Access Compliance Report

Public Rights-of-Way

Intersection ID: 2877	Main Street: GOLDENFIELD_DR	Cross Street: FOGGY_MEADOW_RD	Location: W
ADA ID: 331A367CA4FA	Ramp Type: BlendTrans1	Initial Pass/Fail: Pass	Overall Compliance: No
			Severity Score: 12.75

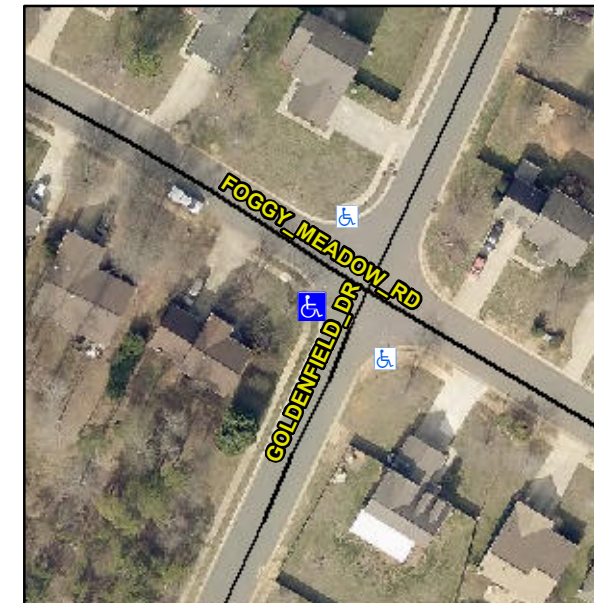
CURB GAP 2.0

Not Found, R304.5.3, R304.2.1, R304.2.2-Perp, R304.3.2-Para, R305.2, R302.7.2, R304.5.4

Compliance	Description	Data	Compliance	Description	Data
N/A	Ramp Length (in)	47.0	Yes	BlendTrans Slope (%)	5.0
Yes	Ramp Width (in)	48.0	No	BlendTrans XSlope (%)	3.0
N/A	Flare Type LT	Sloped	N/A	Flare Type RT	Sloped
N/A	Flare Slope LT (%)	2.7	N/A	Flare Slope RT (%)	6.5
N/A	Flare Traversable LT?	No	N/A	Flare Traversable RT?	No
No	Landing Length (in)	45.0	Yes	DWS Provided?	Yes
Yes	Landing Width (in)	48.0	Yes	DWS Contrast?	Yes
No	Landing Slope (%)	2.3	Yes	DWS Length (in)	25.5
No	Landing X Slope (%)	4.6	Yes	DWS Full Width?	Yes
N/A	Landing Curb? (Y/N)	No	No	DWS Offset (in)	2.5
N/A	Shared Landing?	No			
Yes	Gutter Ponding?	No	No	Gutter Slope (%)	6.4
No	Gutter Lip Ht (in)	0.5	No	Gutter X Slope (%)	3.5
N/A	Painted X Walk1?	No	N/A	Painted X Walk2?	No
	X Walk 1 Direction	To SE		X Walk 2 Direction	To NE
	X Walk 1 Width (in)	N/A		X Walk 2 Width (in)	N/A
	X Walk 1 Slope (%)	1.2		X Walk 2 Slope (%)	4.5
	X Walk 1 X Slope (%)	4.7		X Walk 2 X Slope (%)	2.6

N/A	Ramp inside XWalk1?	N/A	N/A	Ramp inside XWalk2?	N/A
	Road Slope (%)	2.9		Clear Space?	Yes
	Road X Slope (%)	4.1	N/A	Clear Space to XWalk (in)	N/A
Yes	Any Obstructions?	No	Yes	Storm Grate/Utility Hazard?	No
	Obstruction Type			Storm Grate/Utility Type	
		N/A			N/A
			Yes	Surface Condition? (G/P)	Good
			No	Curb Slope (%)	13.6

Remove & Replace Curb Ramp With Two New Directional Ramps or Equivalent. Remove & Replace Gutter.
